4727 12th Avenue NE
APN: 674670-1970
Zoning: SM-U 75-240 (M1)
Overlay: University District NW Urban Center Village
Lot Area: 4500 sf
Current Use: Single Family Residential

EDG RESPONSE

RESPONSE

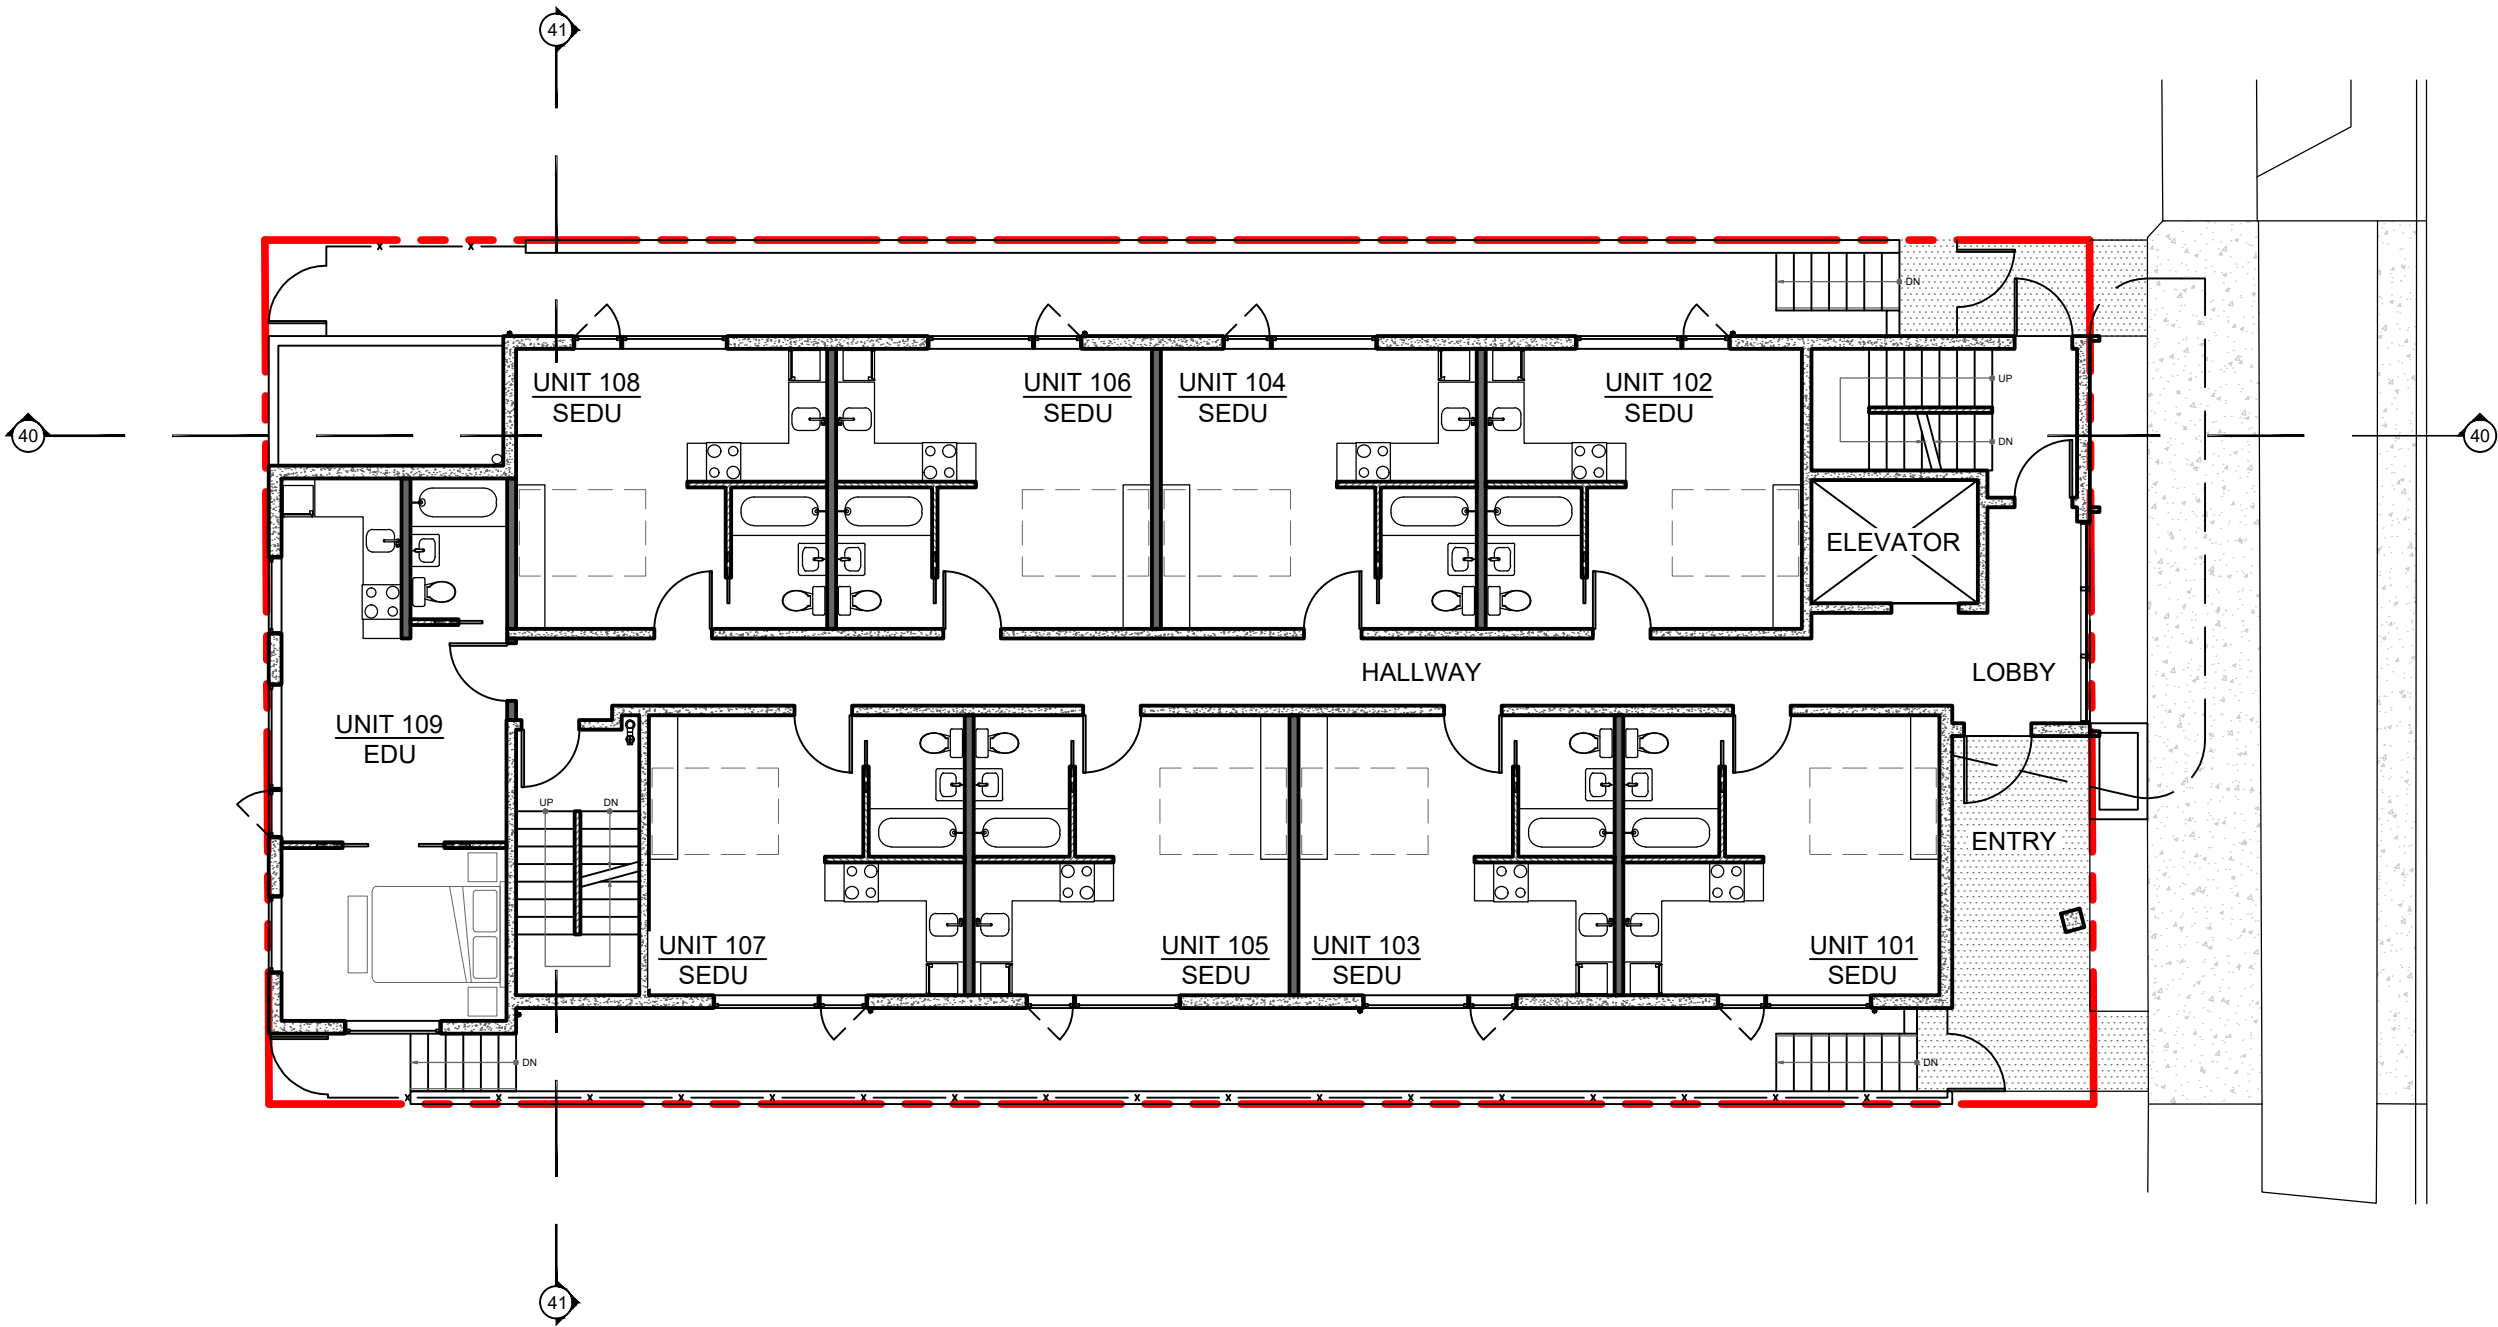
The Board observed that the design proposal did not meaningfully respond to the close proximity of the elevator corridor of the building to the south. The Board thought the units on the south facing façade might be too close to the adjacent building and suggested further review of the floor layout and possible relief to the stack of units that would look out directly onto the adjacent elevator core. The Board agreed with the public comment that the ‘sunken’ walkways located along the north and south of the building could be used as throughways and loitering spaces for transients as they have direct access to the alley. Board members discussed how the spaces could possibly be broken up with a combination of hardscapes, softscapes, or terraced landscaping instead of stairs in order to make the spaces less of an attractive area but decline to make this a specific directive.

- a. The Board stated that they would like to see gates installed to discourage any unauthorized use of those walkway spaces. (PL2-B, CS2-II)

The elevation diagrams show the direct relationships between fenestration on the project façade and the adjacent buildings. Window spacing was modified to reduce overlap at the elevator tower and the patio doors of the adjacent building. Gates have been added to limit and discourage access to the sunken side yard spaces. We are maintaining the stairs from the window wells to maximize ease of egress in case of emergency.

NORTH ELEVATION WINDOW ADJACENCY DIAGRAM

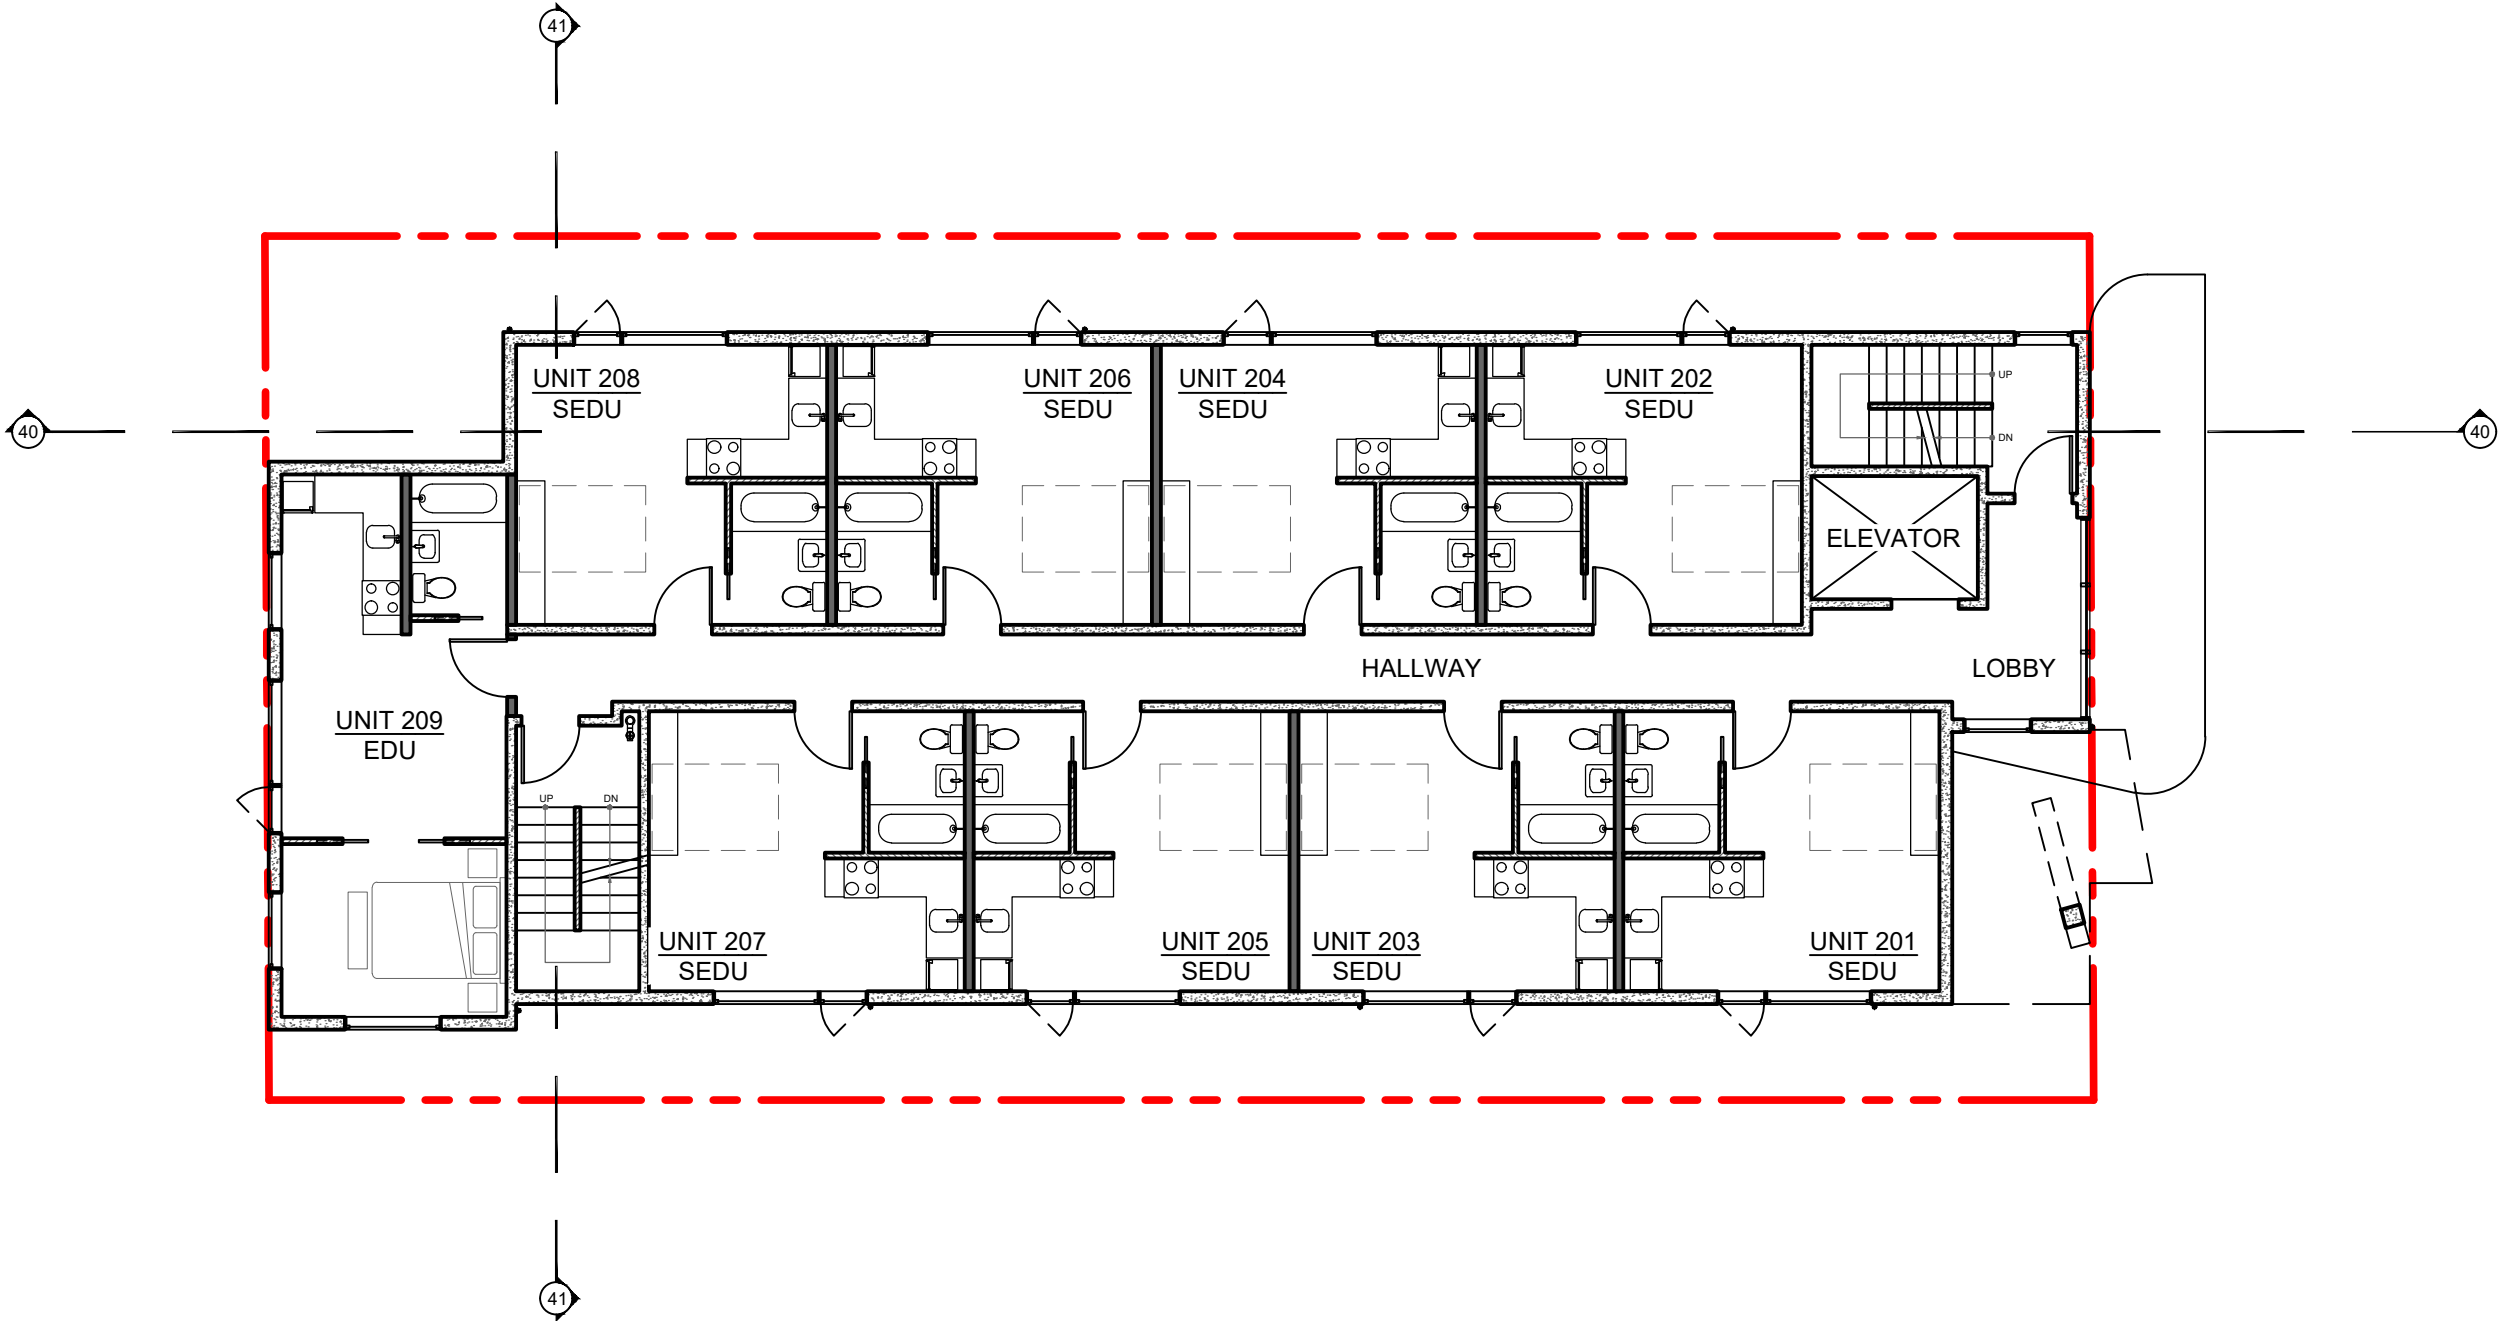
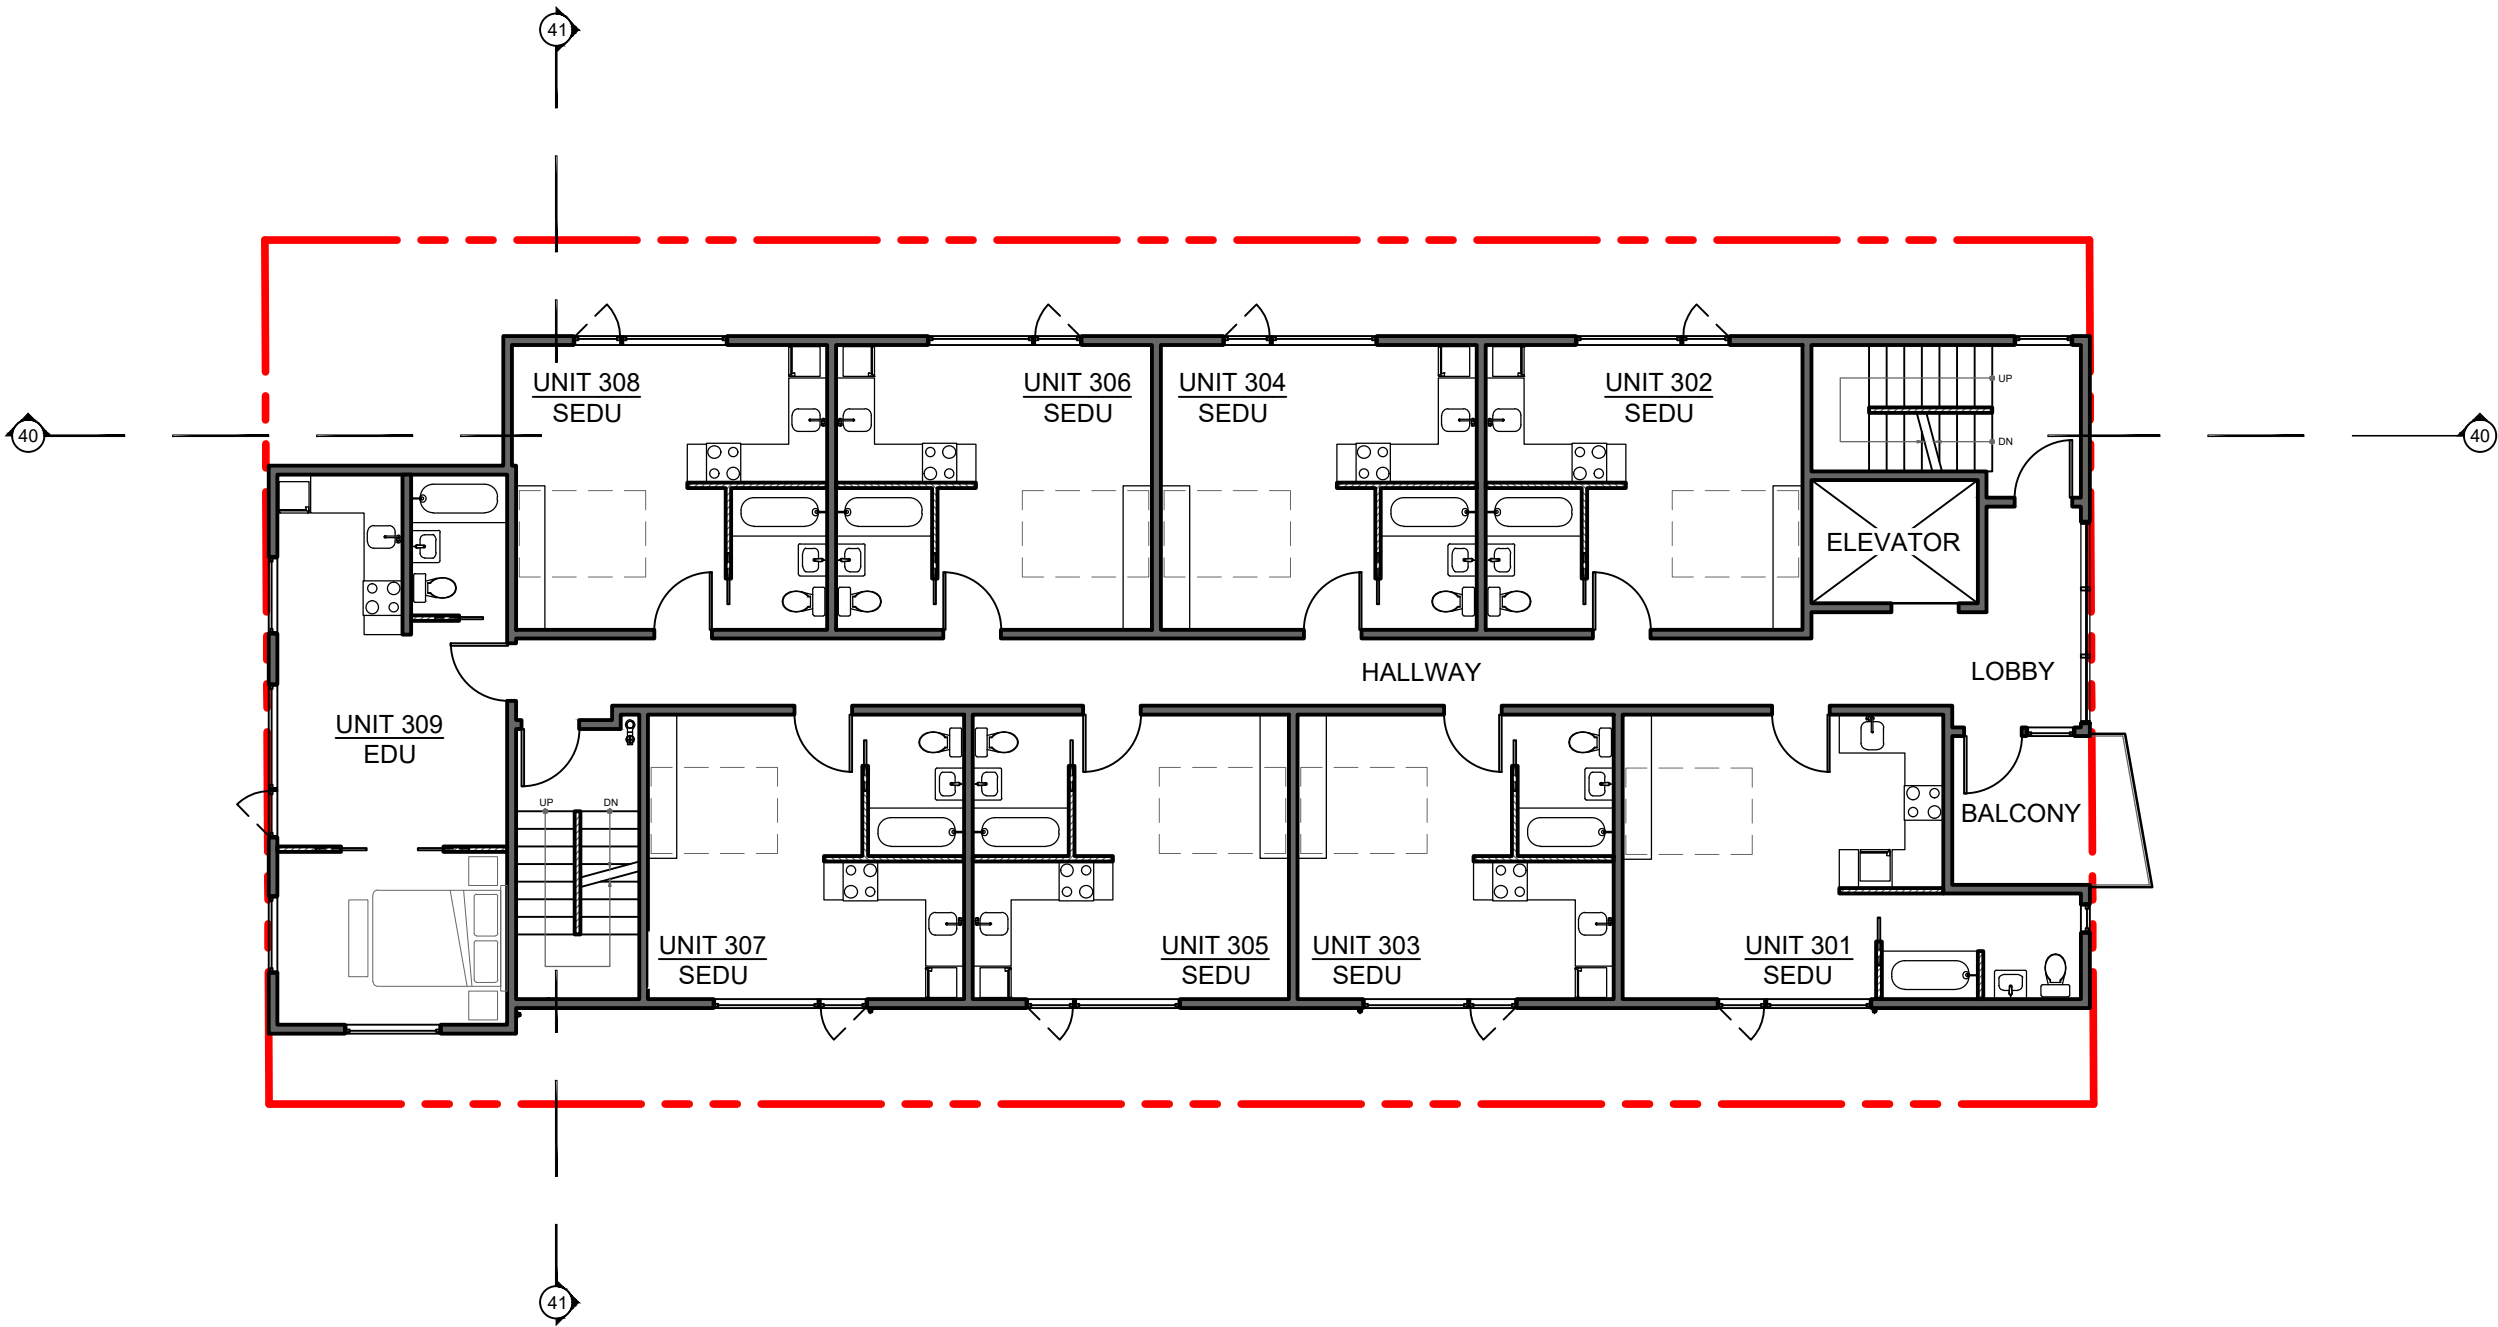
- At the EDG meeting, the following comments were provided:
- Asked if trash could be moved to the opposite side of the building.
 - Expressed concern that the ‘sunken’ walkways located along the north and south of the building designed as emergency egress for basement units will become throughways and loitering spaces for transients as they are connected directly to the alley. As such the commenter requested that gates be installed to discourage any unauthorized use of those walkway spaces.
 - The owner of the hotel expressed concerns about view impacts into their units and asked if floor level heights of the proposed structure would be the same as the motel.
 - Concerned that the building of 67 residential units without parking would be an impact and suggested that a building manager would even have a car – thus needing a place to park.

- While public concerns about the project not providing parking are not addressable, we have addressed the following items:
- The trash room was relocated to an interior enclosed room.
 - The sunken walkways will be outfitted with gates for security.
 - View impacts to adjacent buildings have been analyzed via fenestration diagrams and have been adjusted, where possible, to minimize overlap with neighboring doors and windows.
